SERVICE BULLETIN

SB # 180212-974699-9WE

SUBJECT: Incorrect Nut internal threads causing damage during installation.

Figure 1, Image of Nut-Hex Showing Incorrect Internal Thread

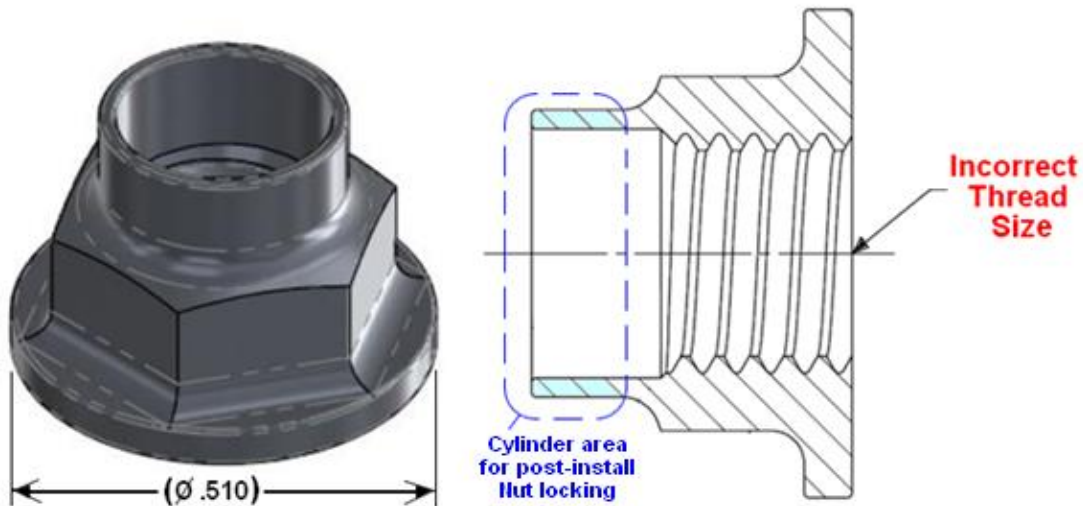
The Nut internal threads were incorrectly designed and manufactured with a threads per inch (TPI) of .250-**32** UNJEF-3B. The correct threads per inch is .250-**28** UNJF-3B.

The incorrect Nut-Hex threads per inch (TPI) would prevent proper installation of the Nut onto the mating shaft of the NHA and the Nut would not be able to be fully installed onto the mating shaft without exceeding the required assembly torque value defined in the NHA CMM. However, if excessive force was used to attempt to fully install the Nut, it would cause thread damage to both the Nut and the mating shaft.

Following the applicable NHA CMM instructions, remove the Wencor Nut-Hex and return the removed Nut-Hex to Wencor. Inspect the mating shaft threads for damage, replace the mating shaft if damaged threads are found. Replace the Nut-Hex with an approved Nut-Hex with the proper threads per inch (.250-28) and properly follow the NHA CMM instructions for assembly.

Figure 2: Example of Nut-Hex Installed into NHA

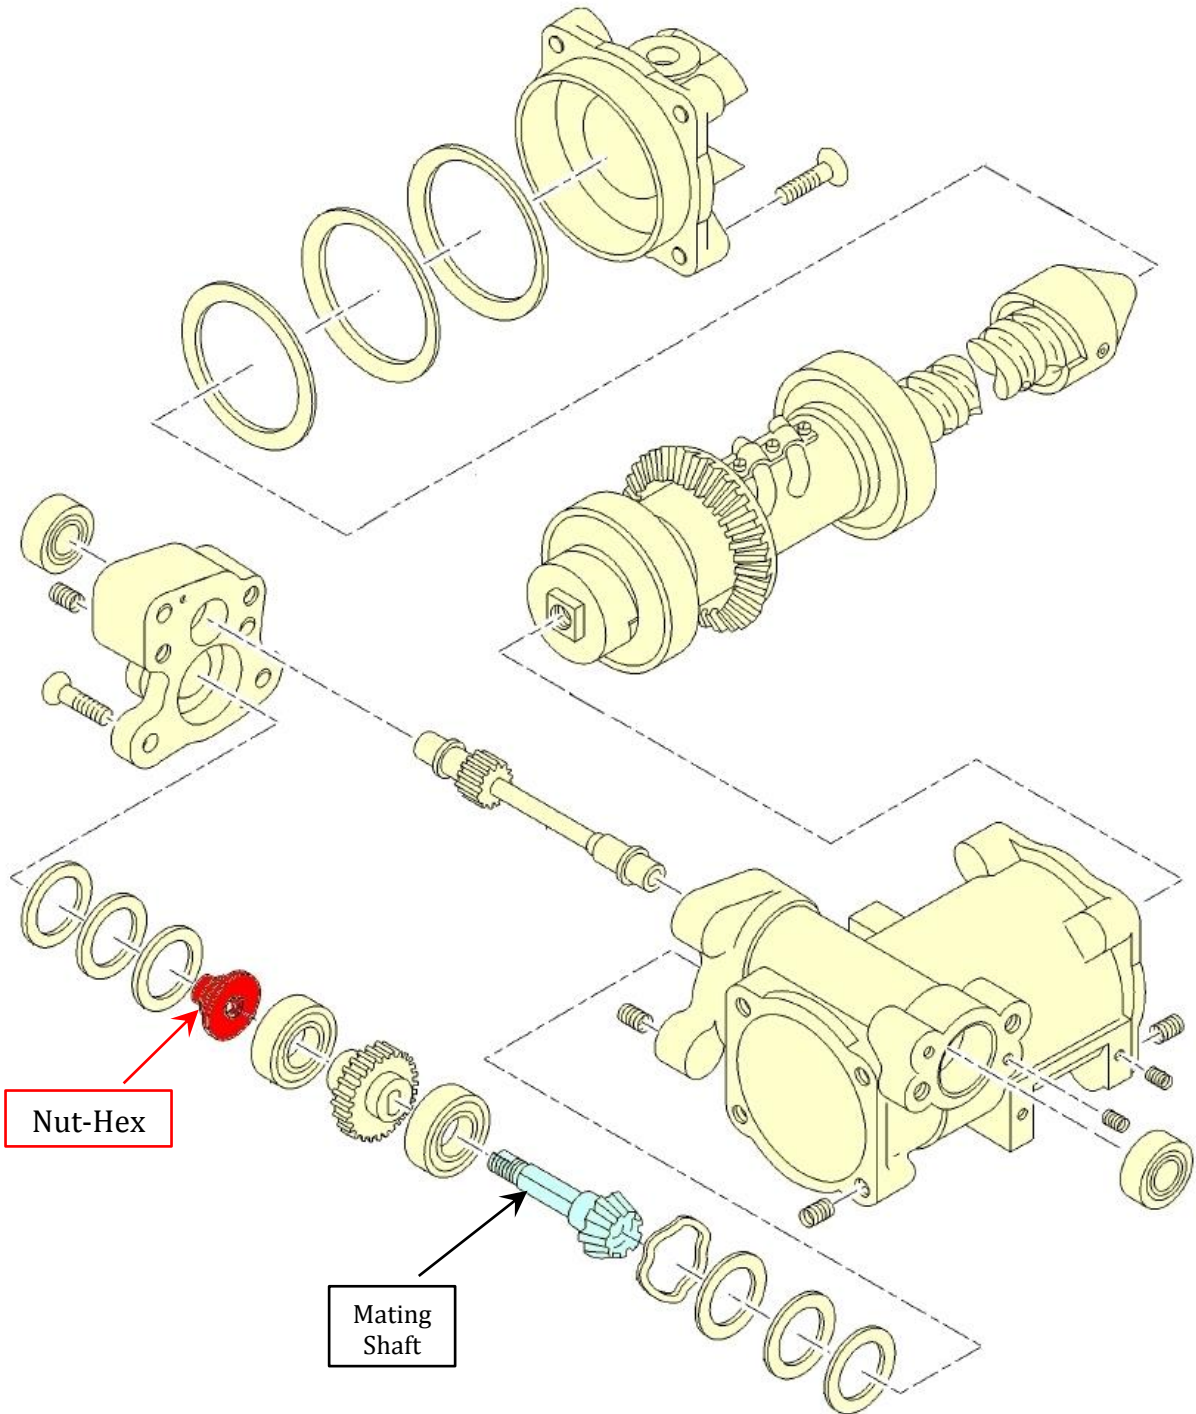
The Nut-Hex is installed into various NHA's and is used as a typical fastener at the end of a shaft in those locations, see one installed example in figure 2 below. The Nut also incorporates an extended cylinder area that is deformed or crimped after being fully installed to ensure the Nut-Hex will not come off the mating shaft, see figure 1 above.
